SI B17 01 18
Cooling Systems

HEATER HOSE IS CONTACTING THE STEERING SHAFT

G12 (740 Li and 740 Li xDrive Sedans)	G30 (540i and 540i xDrive Sedan)	G32 (640 xDrive GT)	
---------------------------------------	----------------------------------	---------------------	--

With the B58 engine

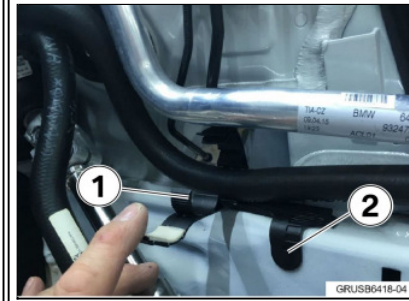
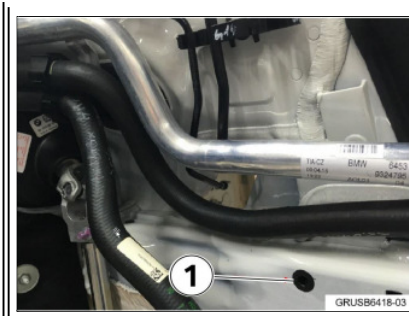
The steering shaft can contact the heater hose, possibly wearing through the hose.

Install a hose retaining bracket to position the hose away from the steering shaft. Replace the heater hose if already damaged.
